NEW LIFE BAPTIST CHURCH

GRADING AND DRAINAGE PLAN

LIFE BAPTIST CHURCH ADDITION GRADING AND DRAINAGE PLAN

NEW LIFE BAPTIST CHURCH ADDITION GRADING AND DRAINAGE PLAN

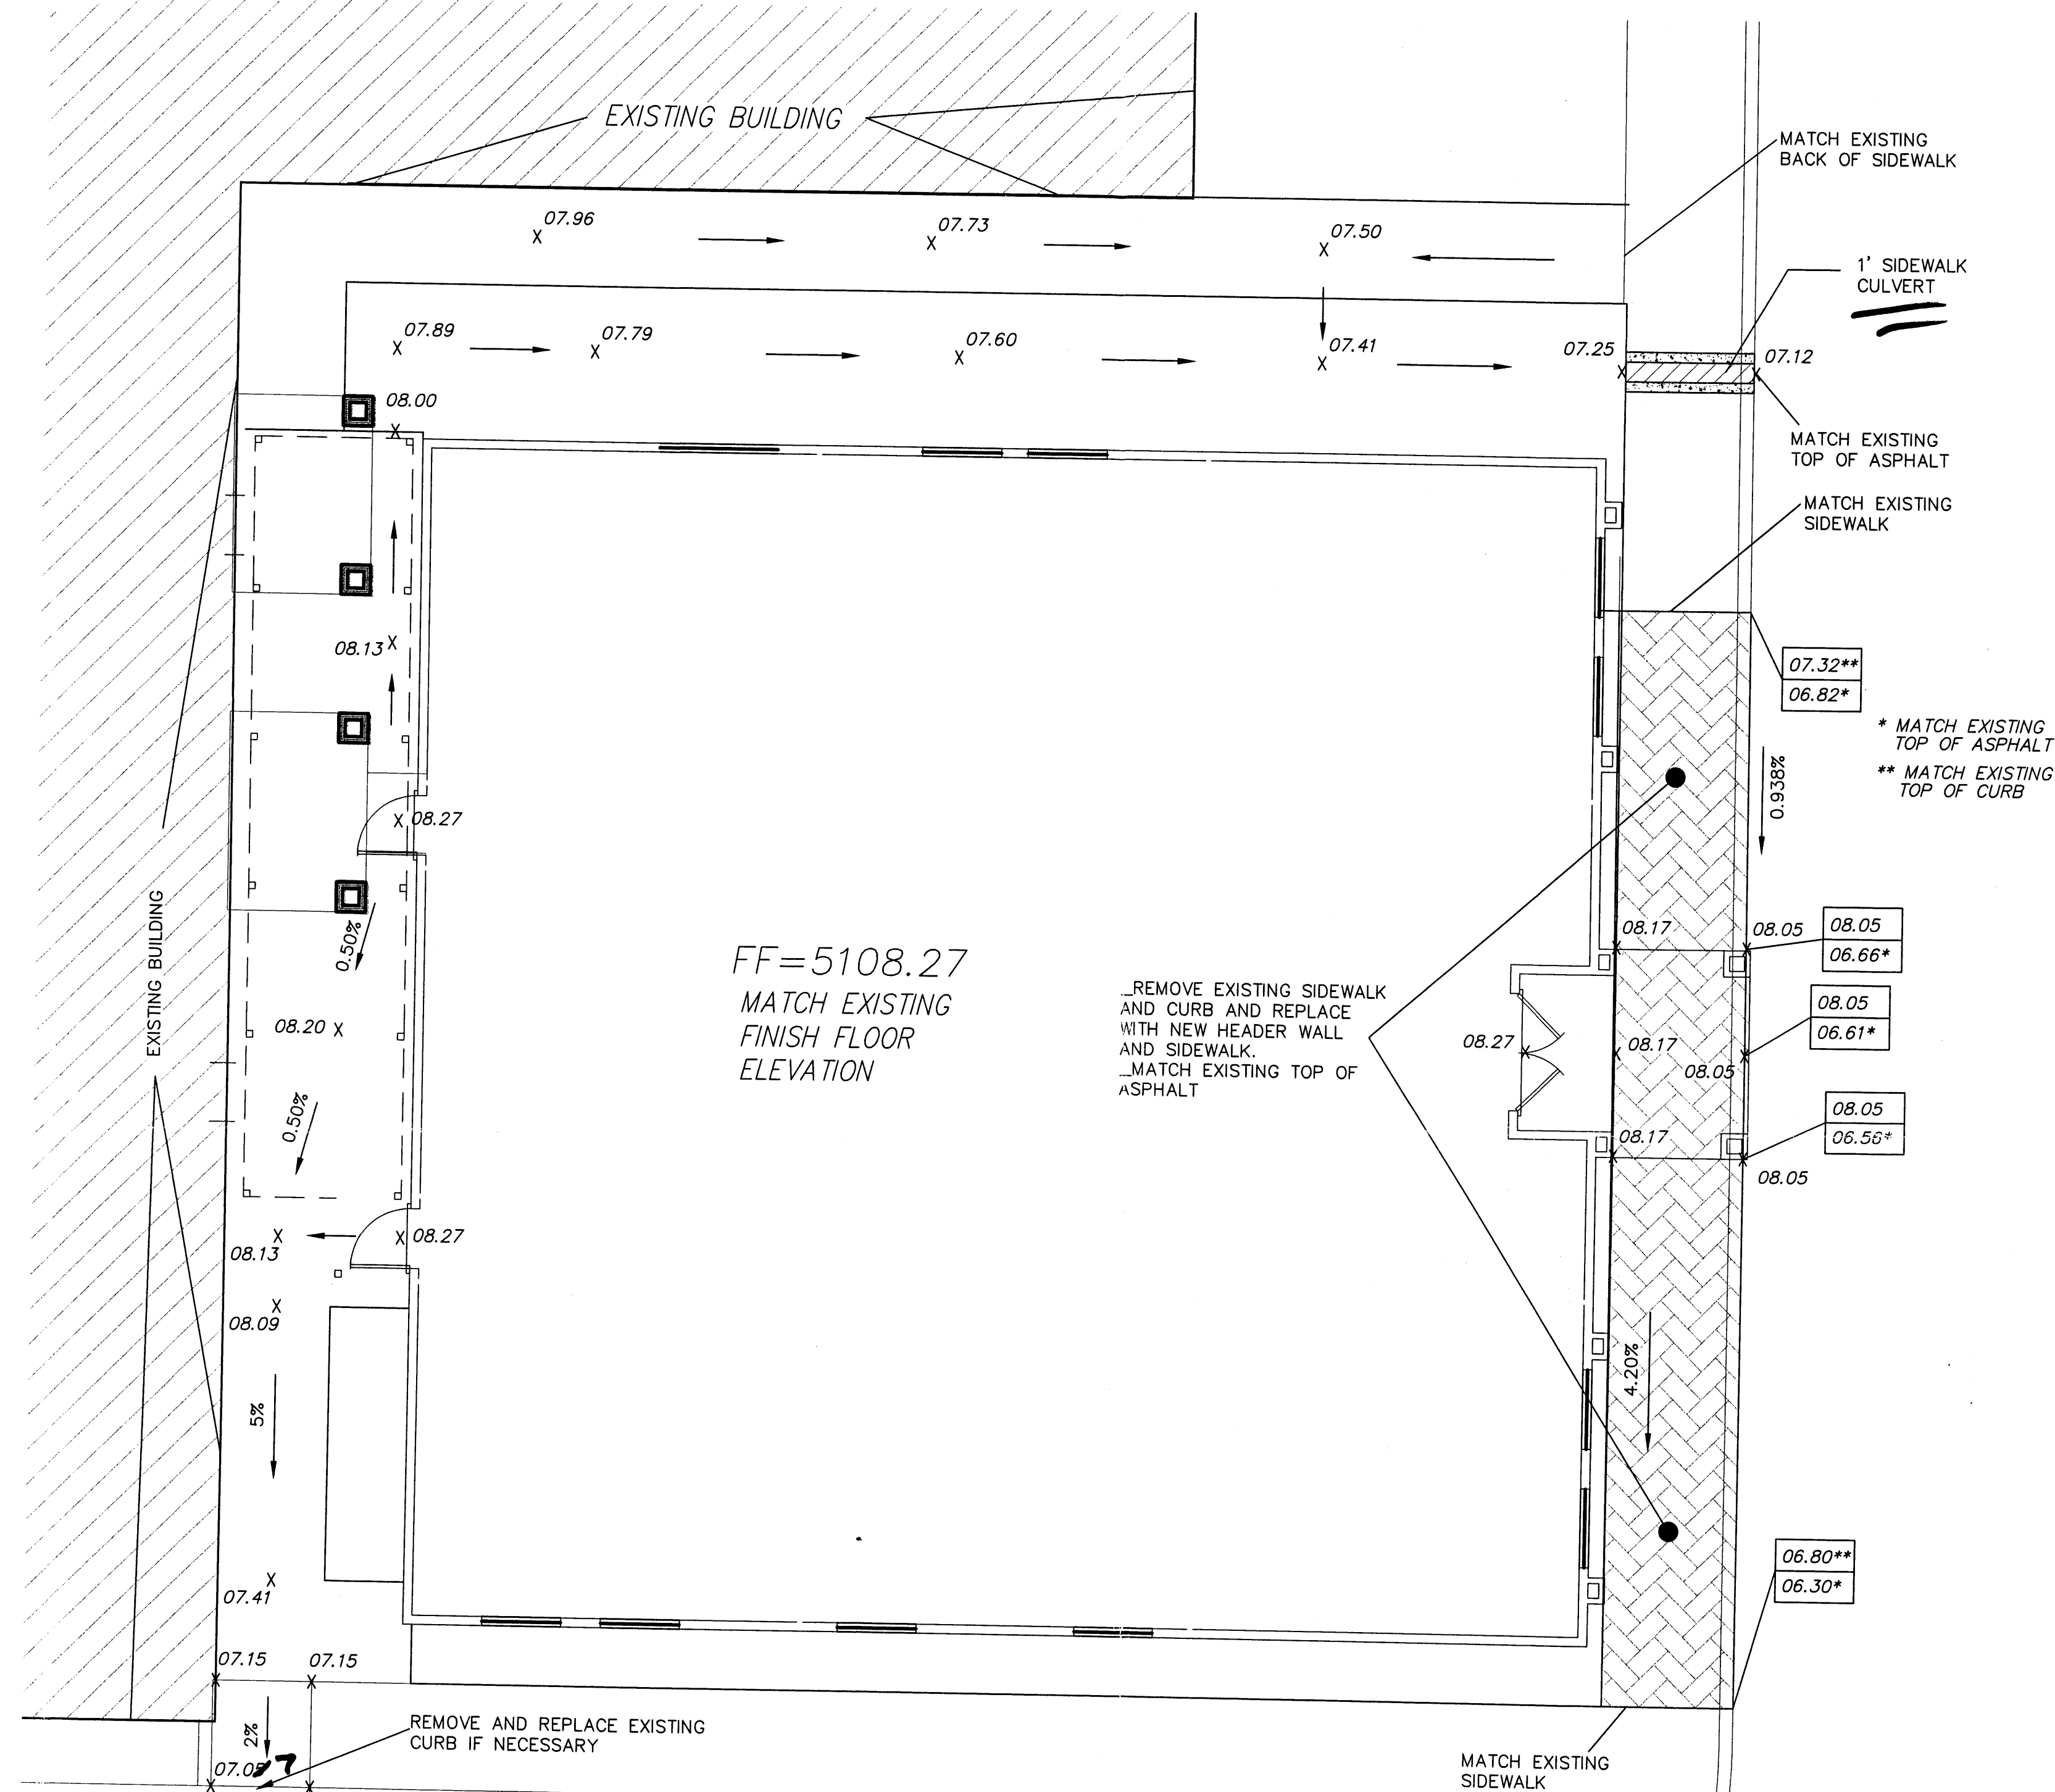
Show location relative to site

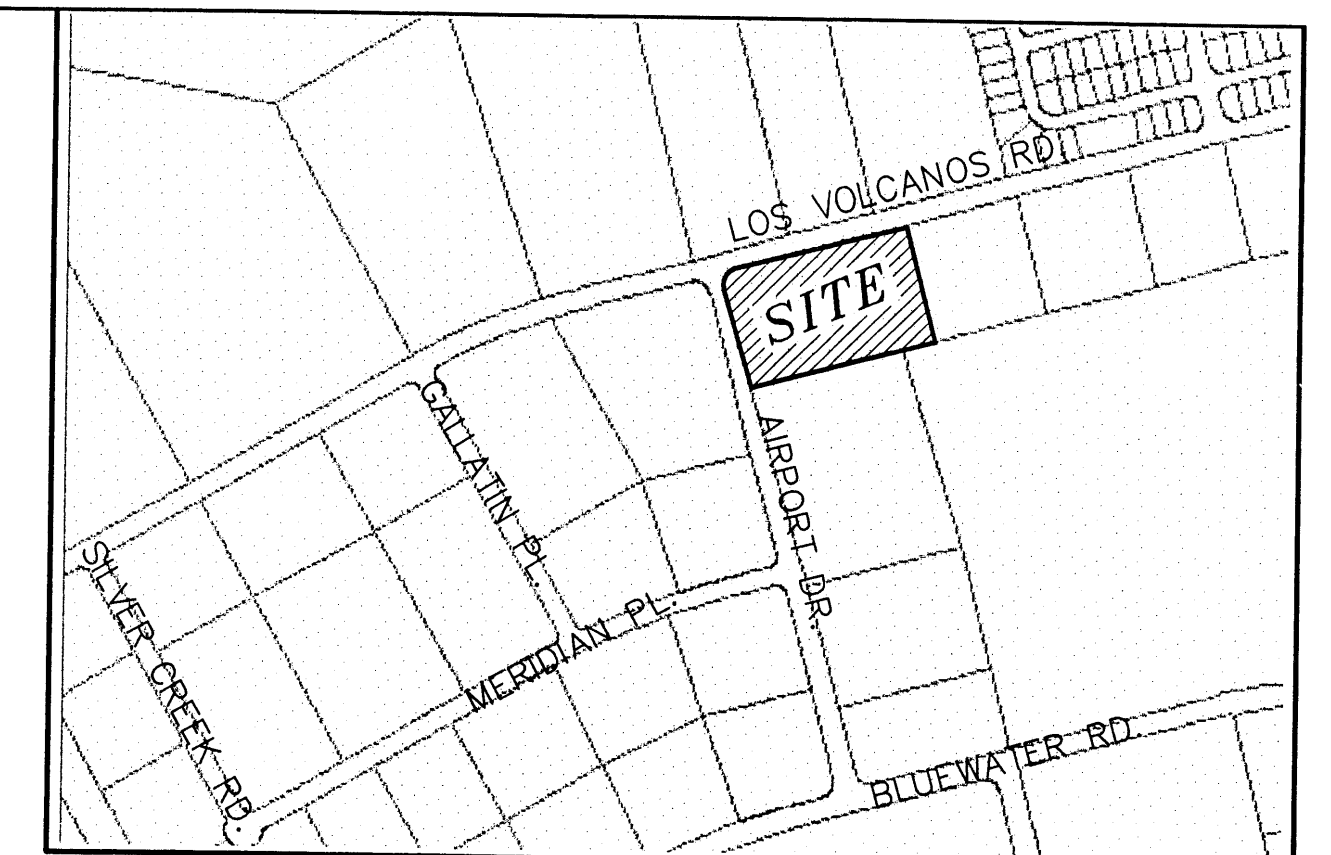
Contours? MARK GOODWIN G.D. Plan Not Included

SITE PLAN

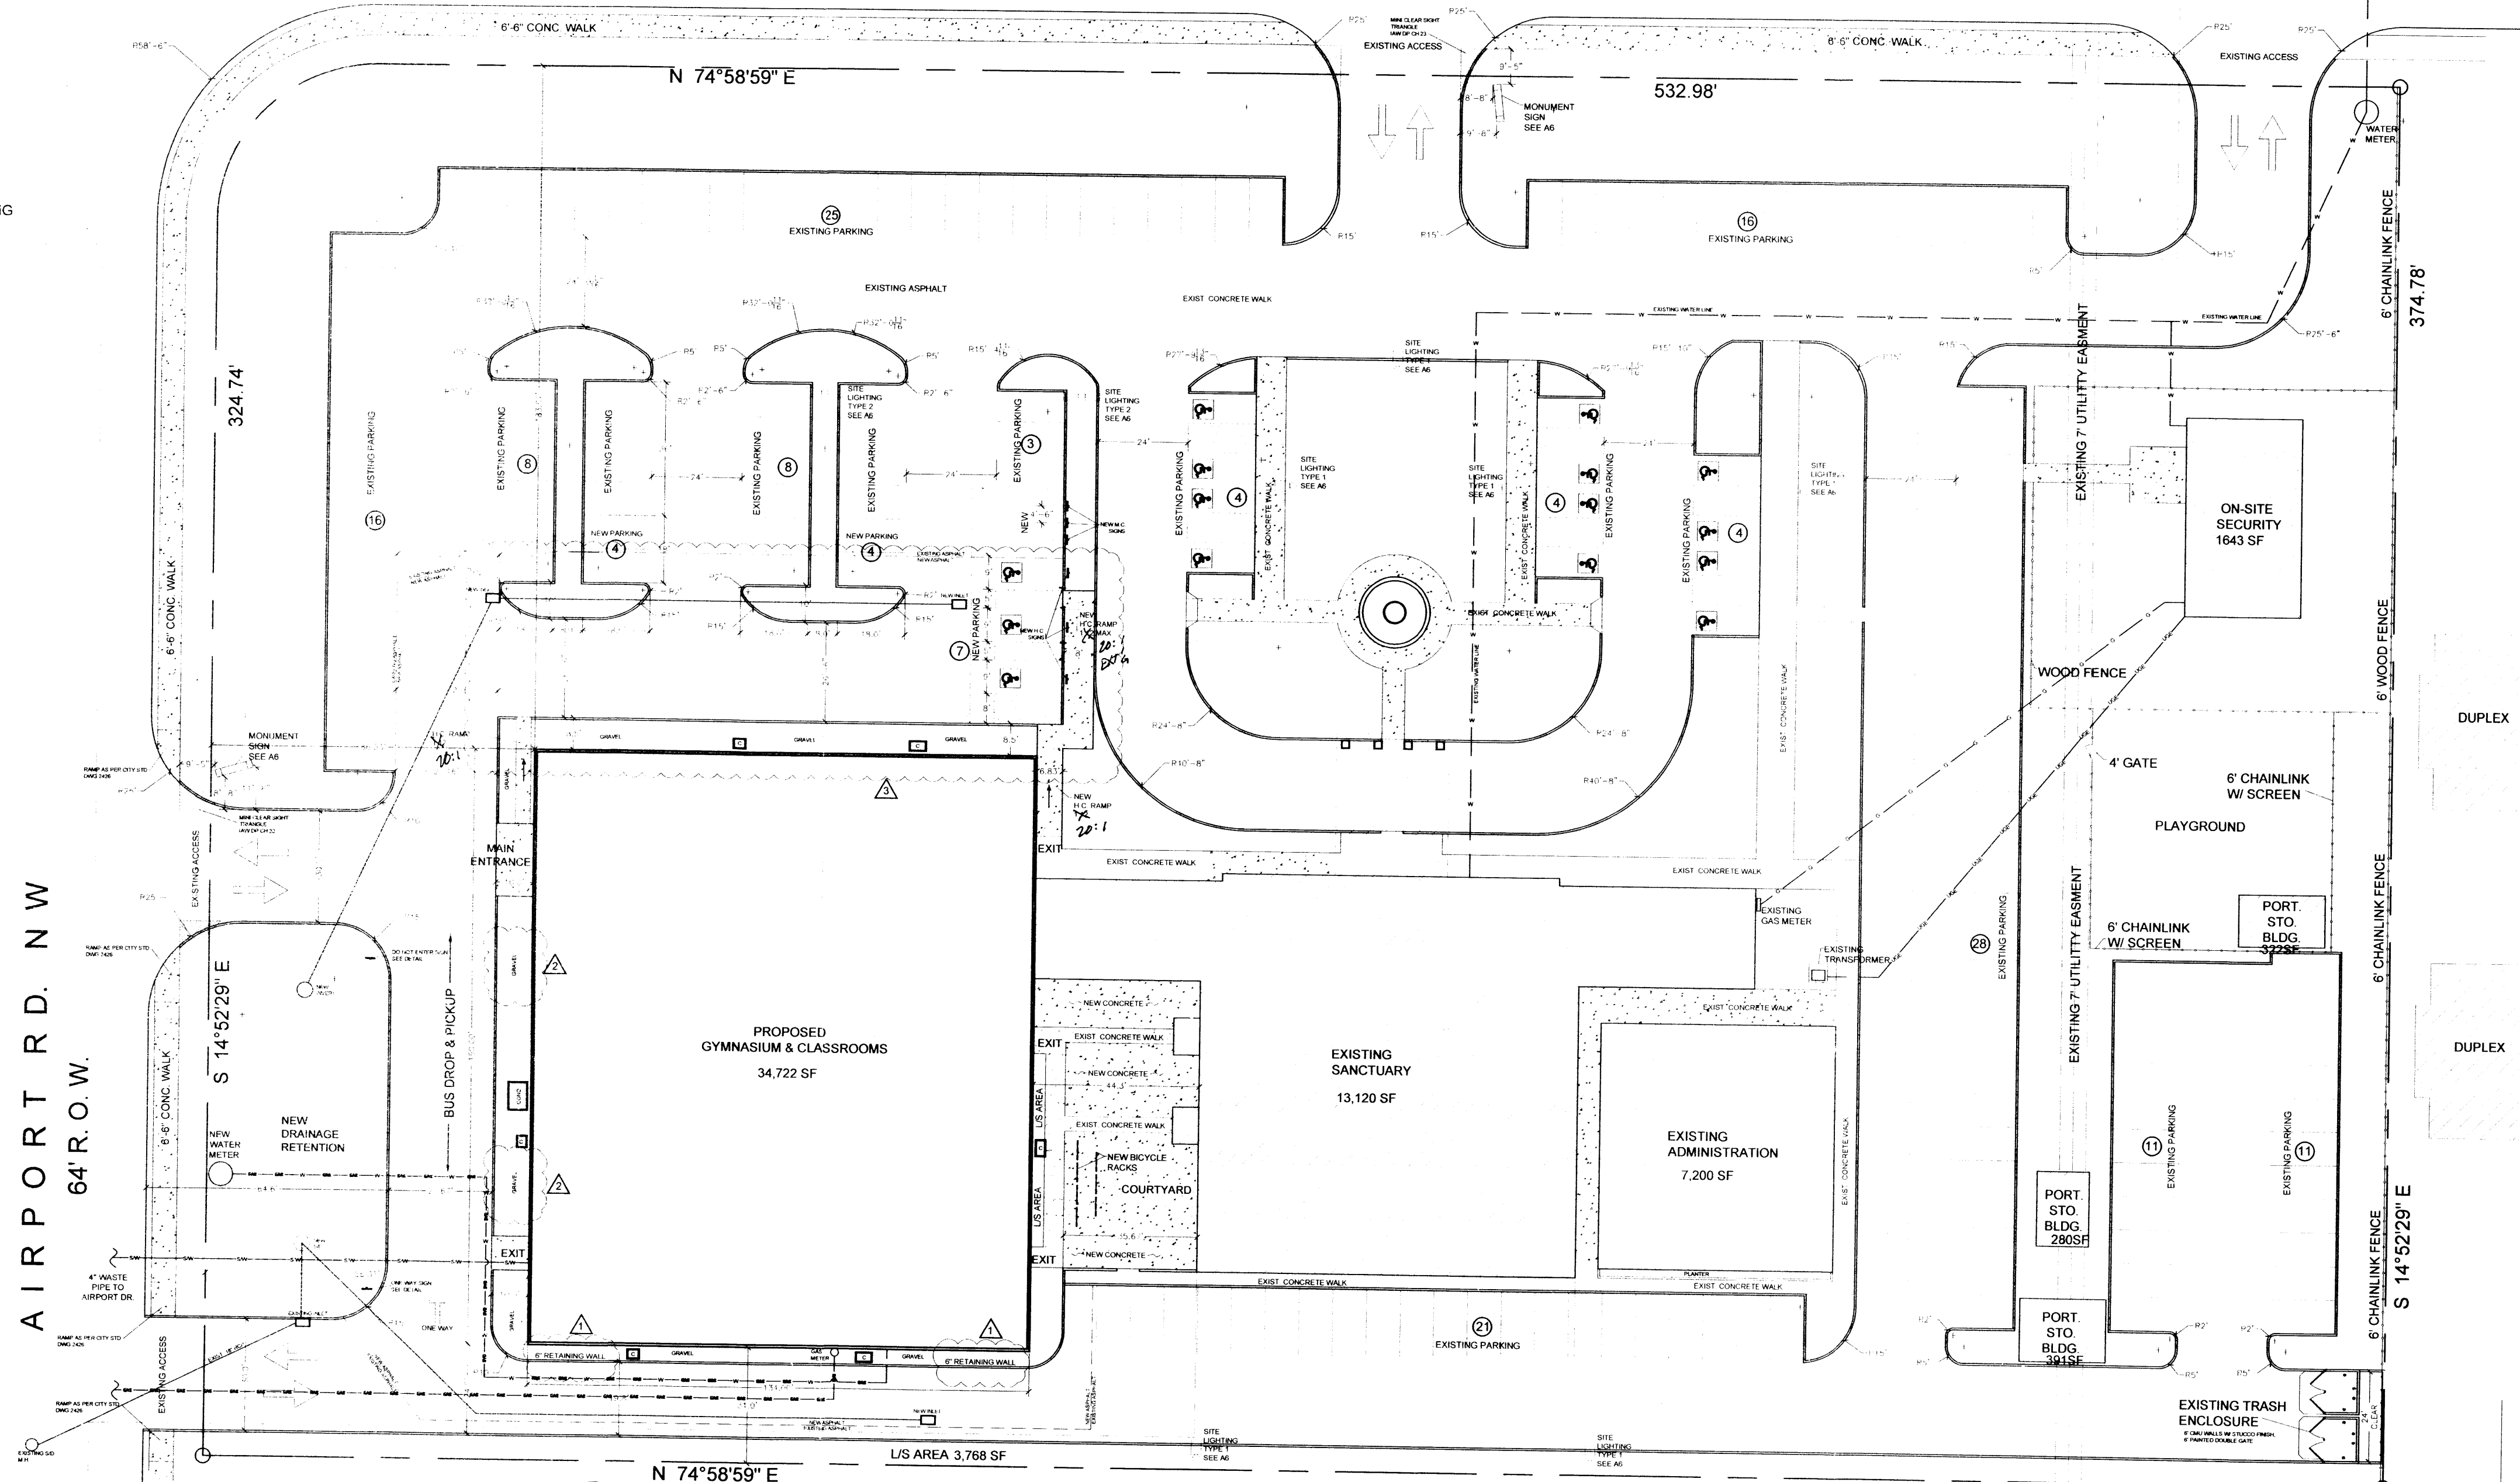
- 8/26/09 ADDITION OF RETAINING WALL ON SOUTH OF BUILDING
- 8/26/09 ADDITION OF GRAVEL IN LIEU OF CONCRETE SIDEWALK
- 8/26/09 RE-CONFIGURE PARKING AREA AS SHOWN
